HISTORIC AND DESIGN REVIEW COMMISSION

HDRC CASE NO: 2020-396
ADDRESS: 1013 E CROCKETT ST
LEGAL DESCRIPTION: NCB 577 BLK 16 LOT A17
ZONING: RM-4, H
CITY COUNCIL DIST.: 2
DISTRICT: Dignowity Hill Historic District
APPLICANT: Erik Campos/CAMPOS ERIK
OWNER: Erik Campos/CAMPOS ERIK
TYPE OF WORK: Carport installation
APPLICATION RECEIVED: August 25, 2020
60-DAY REVIEW: Not applicable due to City Council Emergency Orders
CASE MANAGER: Huy Pham

The applicant is requesting a Certificate of Appropriateness for approval to install an attached carport.

Photographs

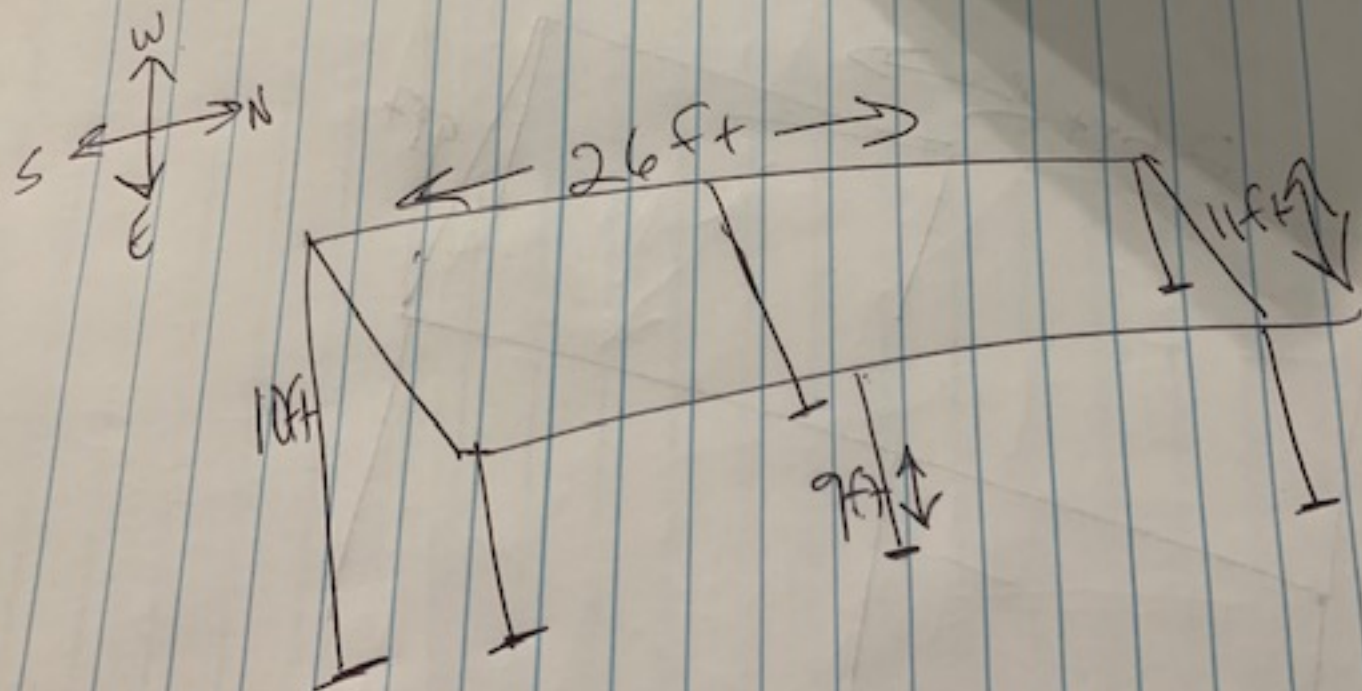
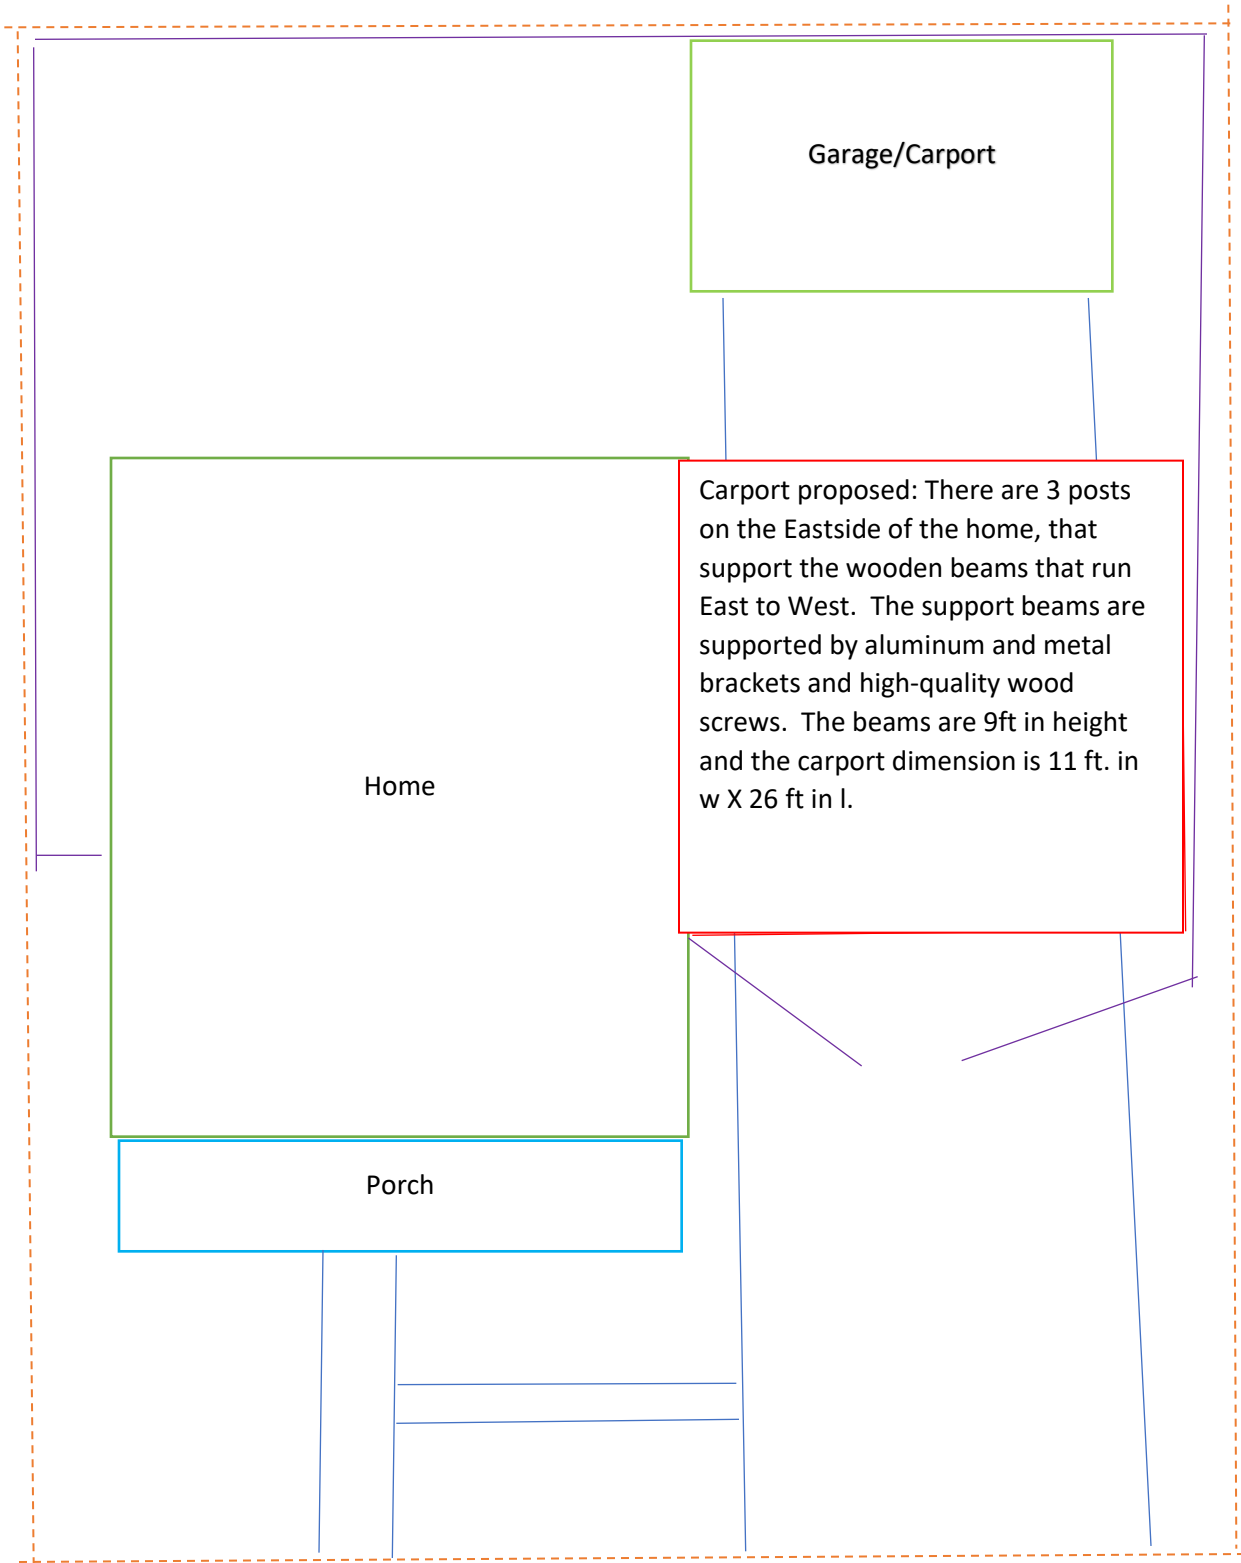
- b. COMPLIANCE – On a site visit conducted on July 29, 2020, staff found that an attached carport was constructed prior to approval. The applicant submitted an application on August 25, 2020 to be heard at the next available Historic and Design Review Commission hearing.

- d. VISUAL IMPACT - Per the Guidelines for Additions 1.A.i., applicants should site residential additions at the side or rear of the building whenever possible to minimize views of the addition from the public right-of-way. Staff finds the addition is visible from the front right-of-way.

Staff does not recommend approval based on the findings. Staff recommends the attached carport is removed and the applicant may resubmit a revised design of a detached structure that excludes polycarbonate roofing panels.

Floor plan

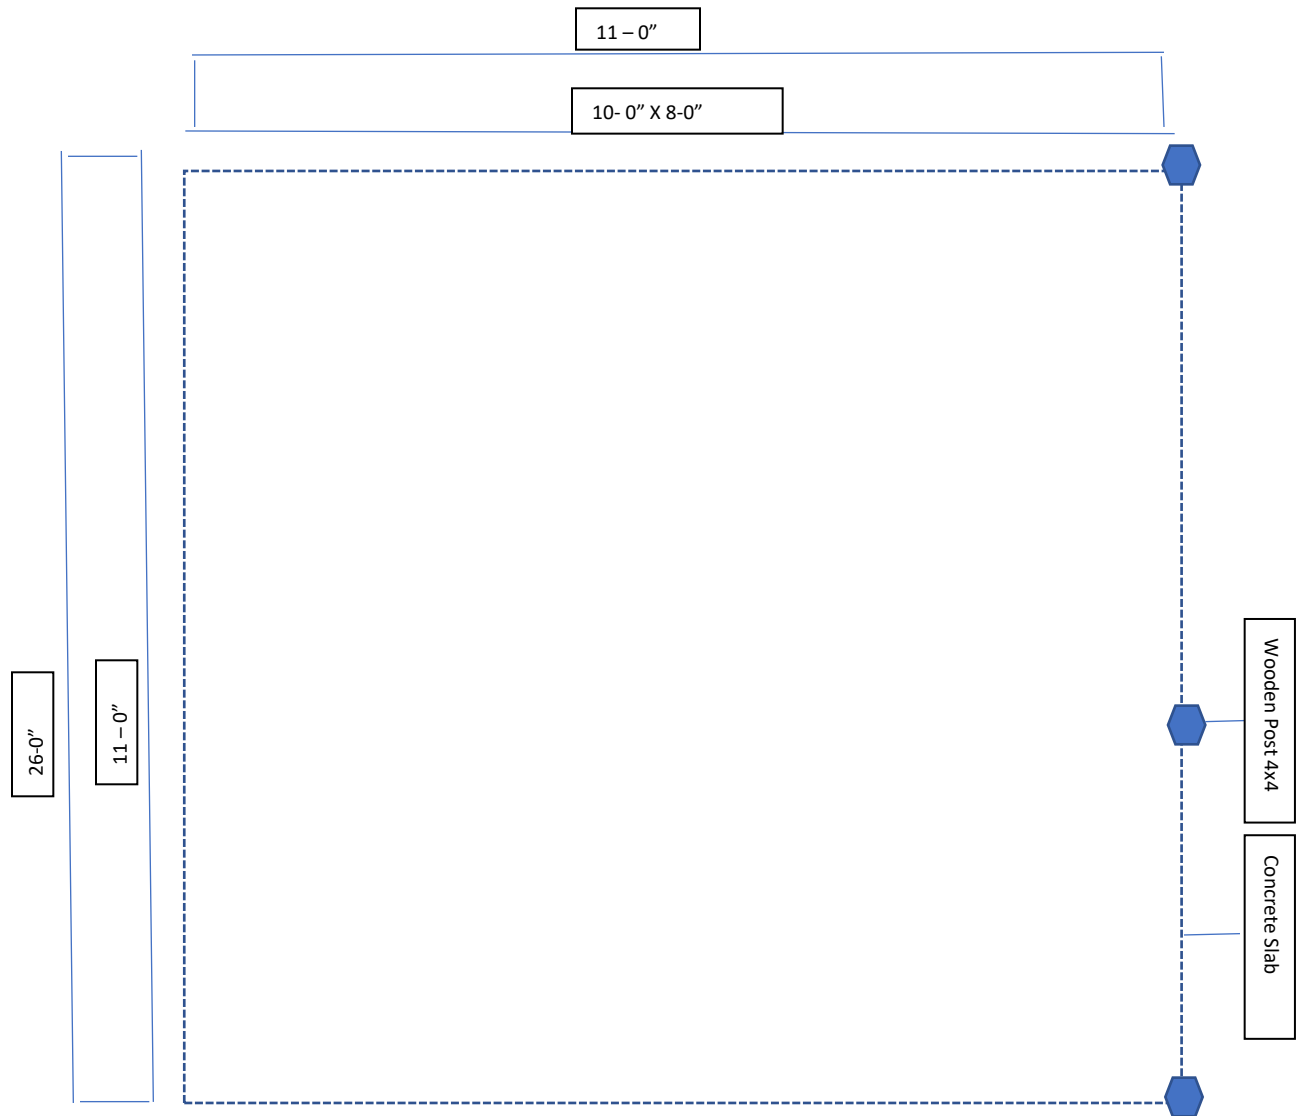
- c. CARPORT – The applicant has proposed to install an attached carport featuring wood construction, “SunTuf” polycarbonate roofing panels, 26 feet in length, 11 feet in width and 10 feet in height.

Material Specs:

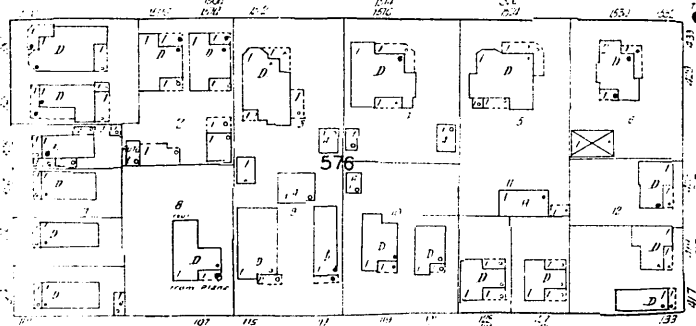
- f. MATERIALS – Per the Guidelines for Additions 3.B.i., applicants should use imitation or synthetic materials, such as vinyl siding, brick or simulated stone veneer, plastic, or other materials not compatible with the architectural style and materials of the original structure. Staff finds the proposed “SunTuf” polycarbonate roofing panels is inconsistent with the Guidelines and should be avoided.
